LIST OF PROPOSED CHANGES:

THE MEADOWLANDS - PROPOSED SITE PLAN CHANGES

BUILDING 1 & 2
 PROPOSED CHANGES - FLOOR PLAN

PROPOSED RETAINING WALL AND PATIO OVERALL PLAN

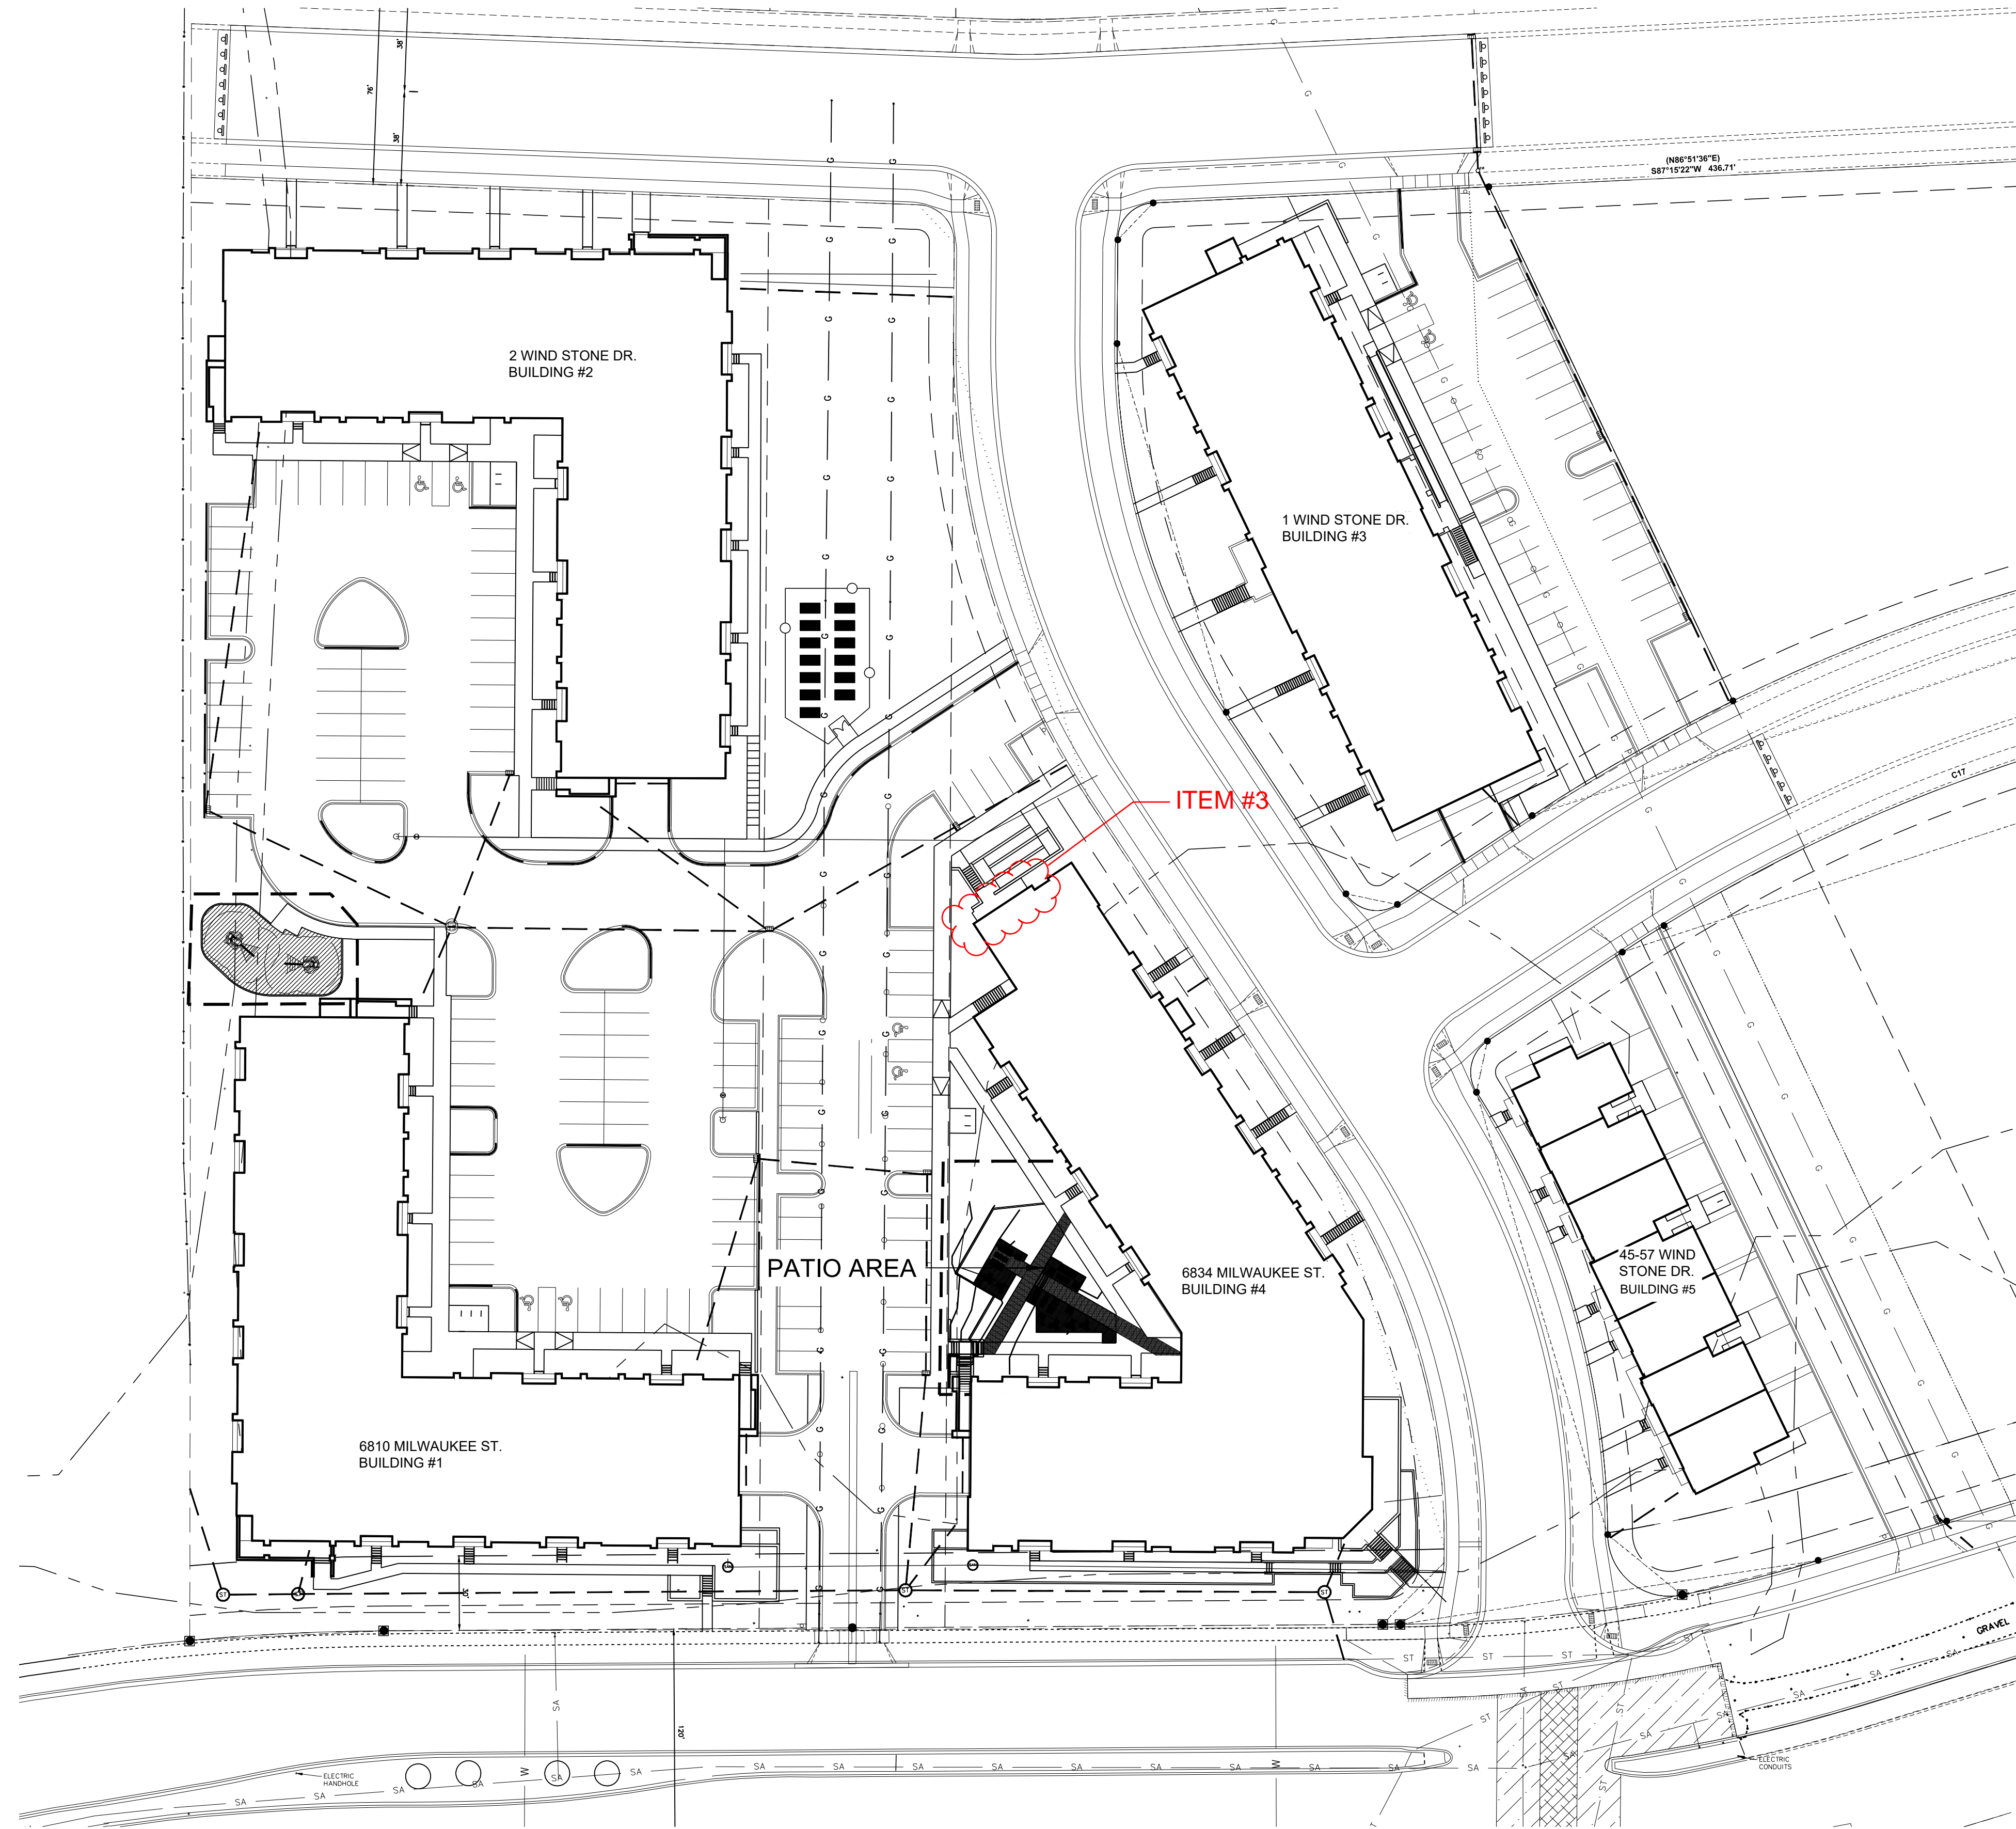
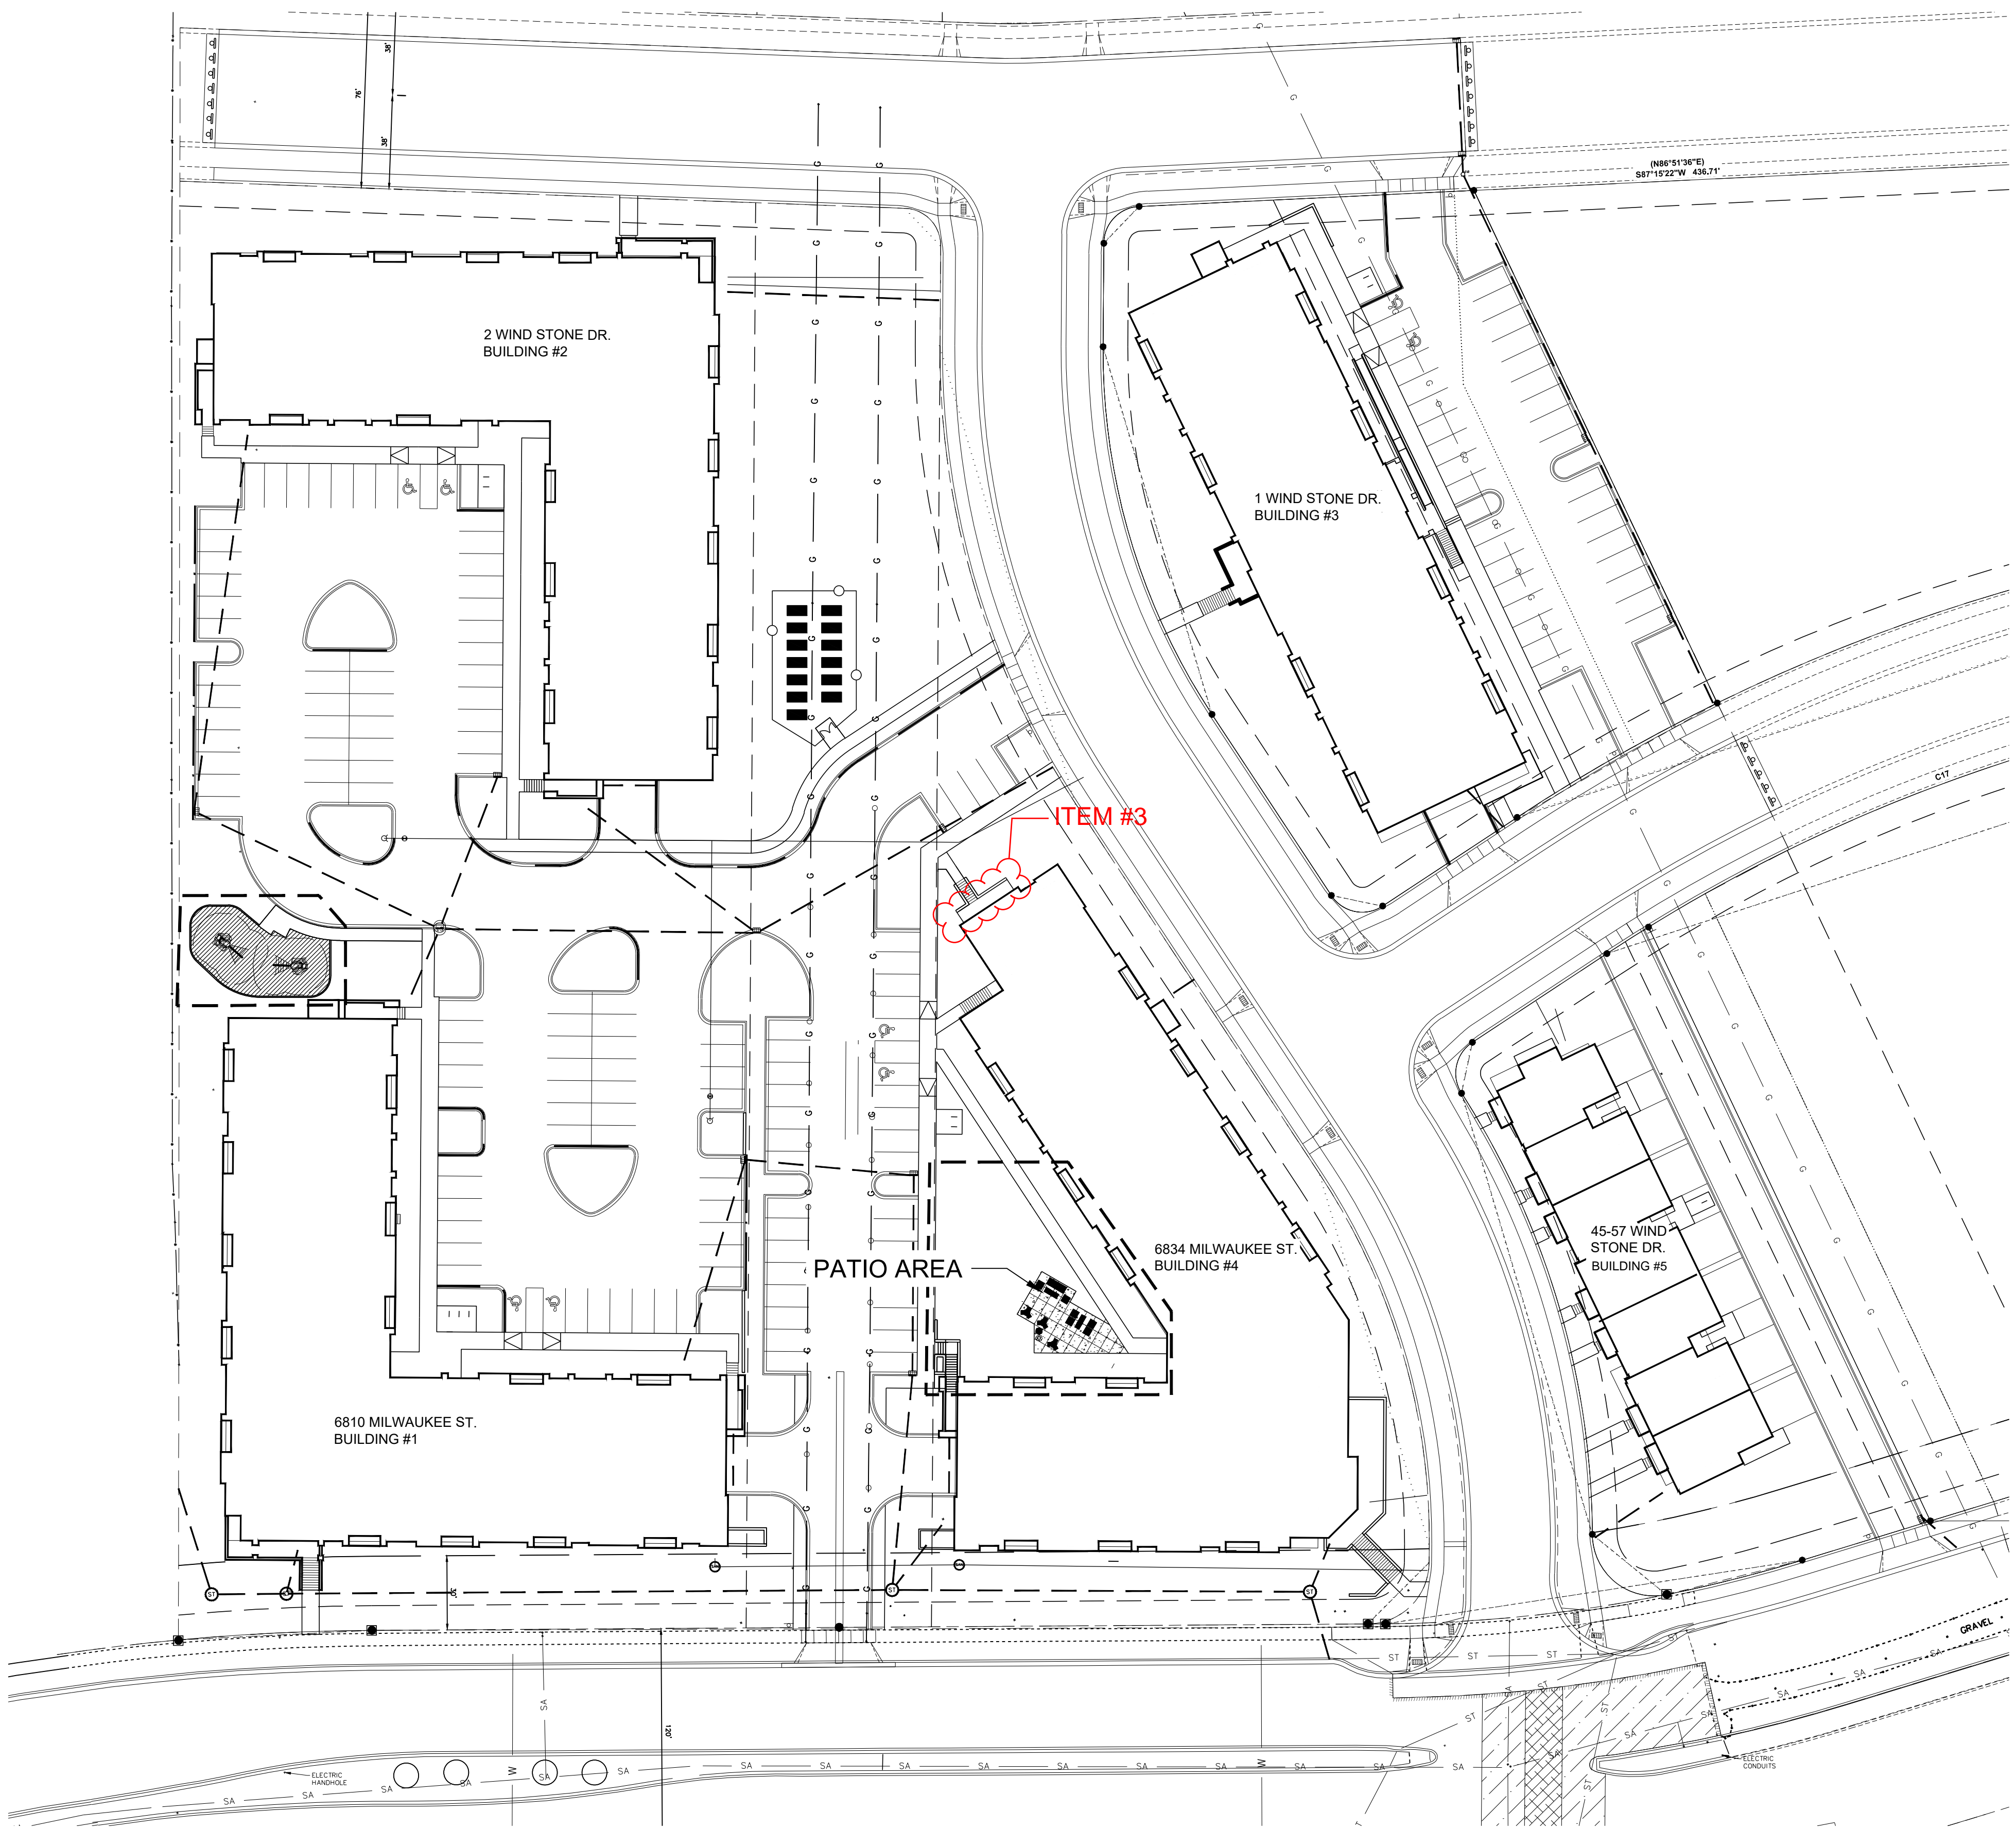
ITEM 3:
 REVISE STOREFRONT APPEARANCE AT THE HUMAN SERVICES OFFICE ON NORTH END OF BUILDING 4.

ITEM 3:
REVISE STOREFRONT APPEARANCE AT THE HUMAN SERVICES OFFICE ON NORTH END OF BUILDING 4.
